TEXAS UTILITIES SERVICES INC.  
2001 BRYAN TOWER · DALLAS, TEXAS 75201

Log # TXX-3389  
File # 10013

SUBJECT: COMANCHE PEAK STEAM ELECTRIC STATION  
EMERGENCY PLAN DISCREPANCIES

REF: LETTER OF JULY 23, 1981 TO MR. R. J. GARY  
FROM MR. R. L. TEDESCO

FIGURE 4.1

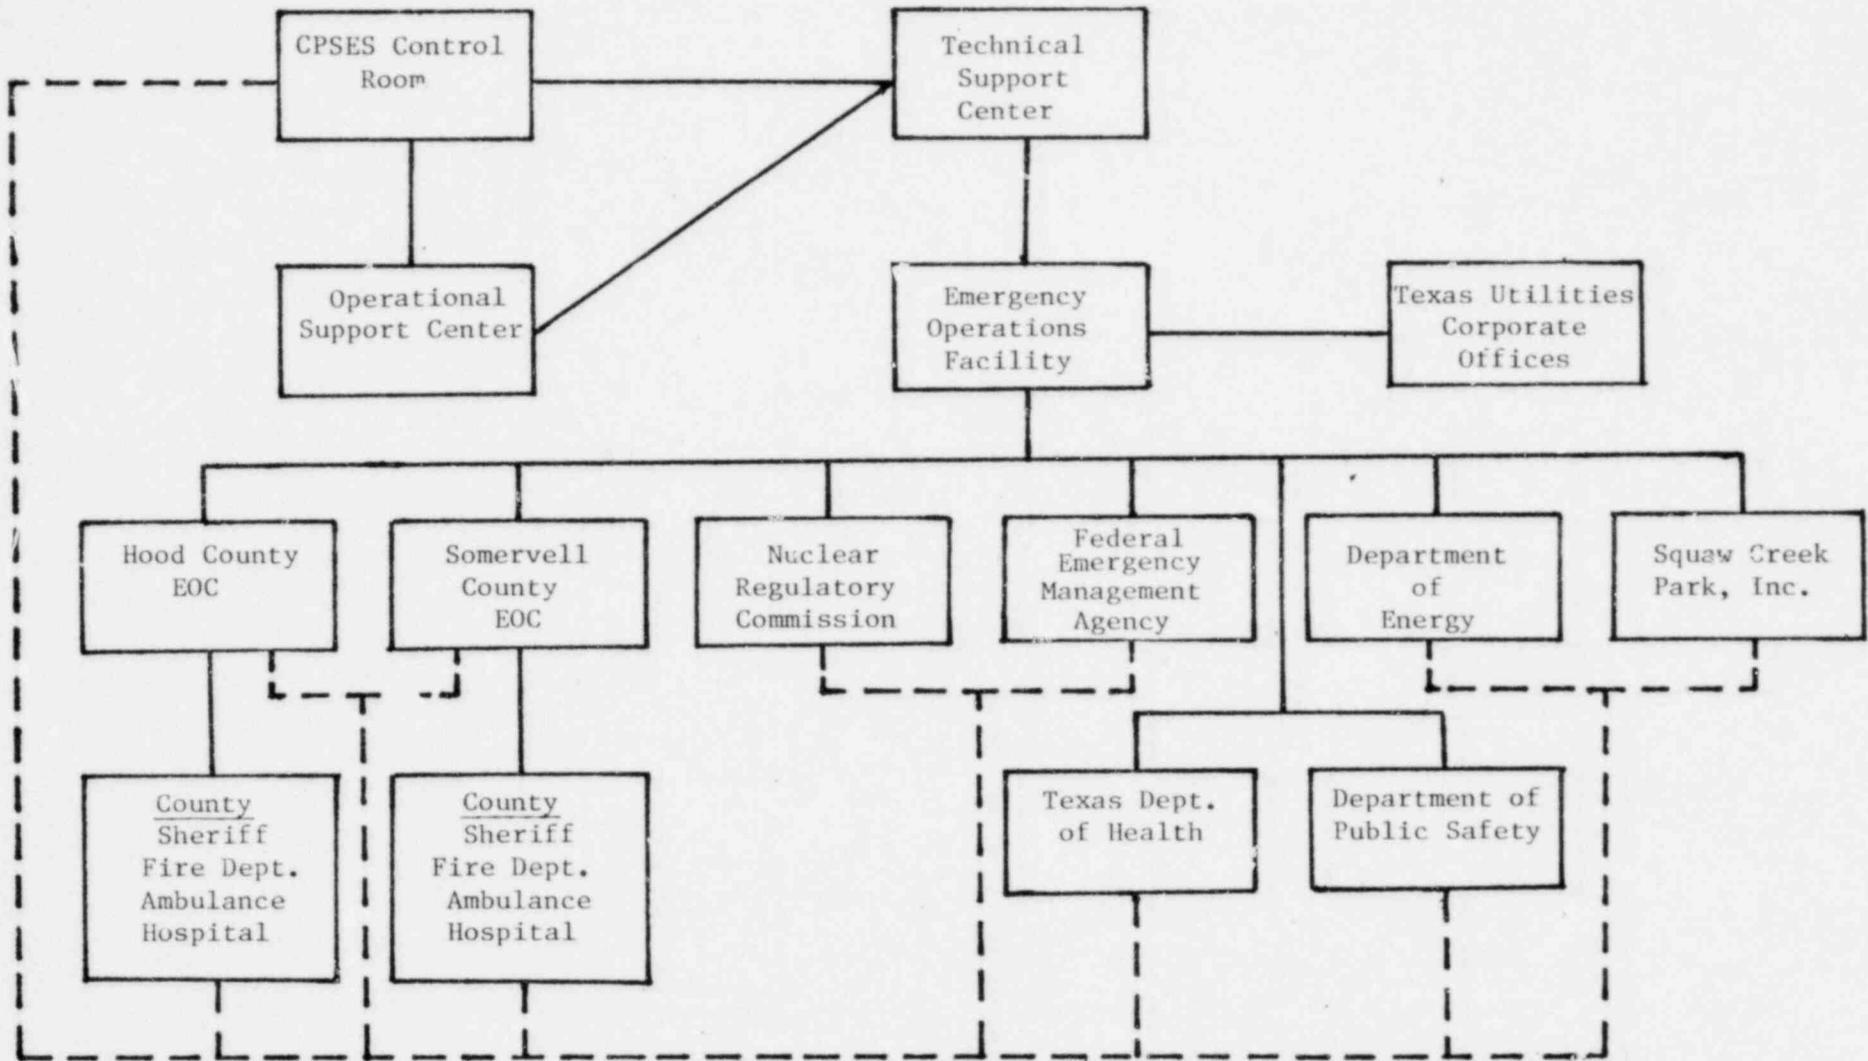
Q The Plan, Figure 4.1, does not illustrate the interrelationship of all those State and local agencies identified in Section 4.3 as support organizations. Revise Figure 4.1 to provide this information. (A.1.c)

Response: Attached is a copy of Figure 4.1 as it may be amended in the next revision of the Plan (Attachment 2).

FIGURE 5.1

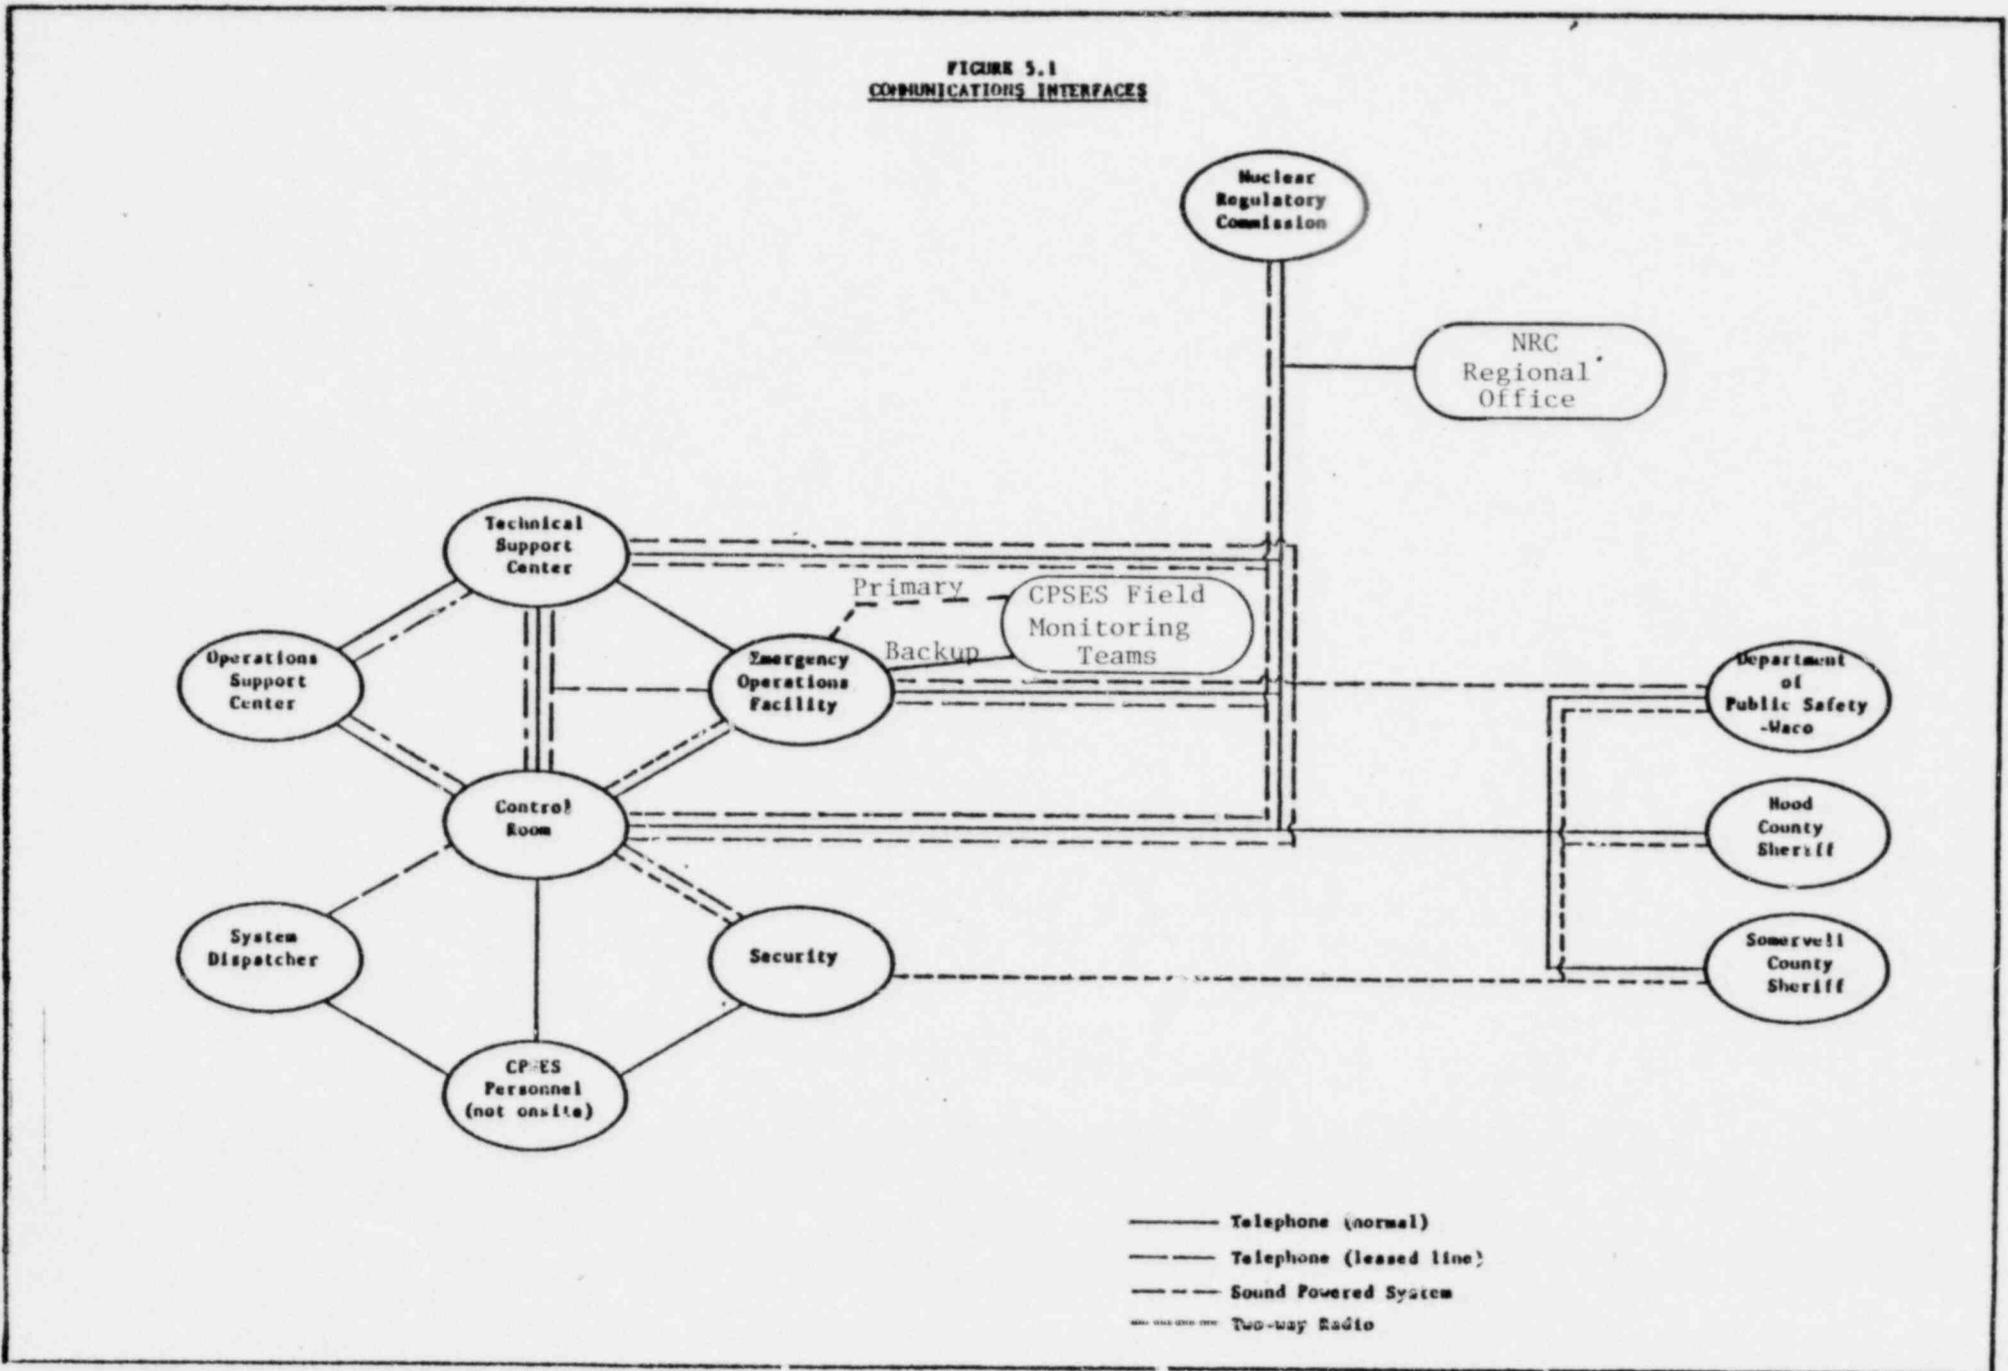
- Q Include provisions for communications by the licensee with NRC headquarters and the NRC Regional EOC, the EOF and radiological monitoring team assembly areas. (F.1.f)

Response: The Plan is being amended to reflect these communication requests. Figure 5.1 is also being altered (a copy is attached, Attachment 3). EOF communications scheme will be in accordance with NUREG-0696.
